Dodge Dakota Fuel Pump Positioning/ Alignment Technical Service Bulletin

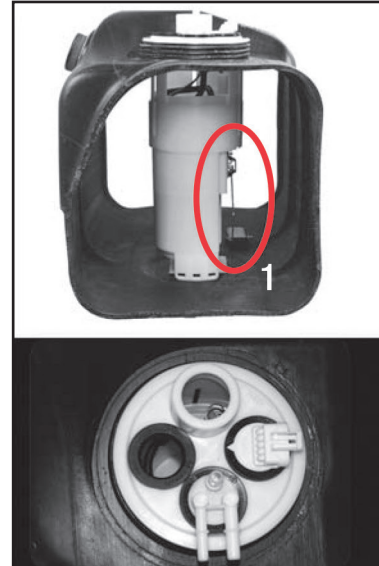
Because of the narrow fuel tank design on Dodge Dakota pickups (1991-96), fuel pump replacement requires precise positioning of the fuel pump module assembly. Improper positioning results in inaccurate fuel-level readings due to obstruction of the fuel-level sending unit float within the tank. Failure to properly align the new pump and installing with even a small amount of offset from the original factory position can lead to binding of the float arm on the fuel tank sidewall.

The fuel pump module assembly, when properly aligned, allows free movement of the fuel-level sending unit float and arm (oval 1).

The fuel pump module assembly, when improperly aligned, causes interference between the fuel-level sending unit float and fuel tank sidewall (oval 2).

The Solution:

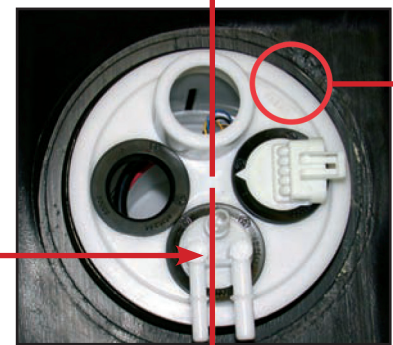
The Airtex E7050M fuel pump module assembly is marked with an alignment arrow to ensure proper positioning. However, in many cases it may be difficult to see the corresponding alignment indicator on the original fuel tank due to dirt, road grime, or tank position when installing the new assembly. If this is the case, refer to the guidelines listed in this document to ensure proper fuel pump module assembly alignment and accurate fuel-level readings.

Ensure that tank alignment indicator is properly positioned relative to the fuel pump module assembly alignment indicator (top photo detail). If alignment indicators are not visible due to contamination or fuel tank position, ensure that pump is positioned per the reference marks relative to the front and rear of the vehicle.

If vehicle fuel lines do not align with pump fuel line outlet, reposition pump fuel line outlet ONLY (not entire module) by turning clockwise in its grommet.

NOTE: Verify proper tank to fuel pump module assembly alignment after final tightening of lock ring.
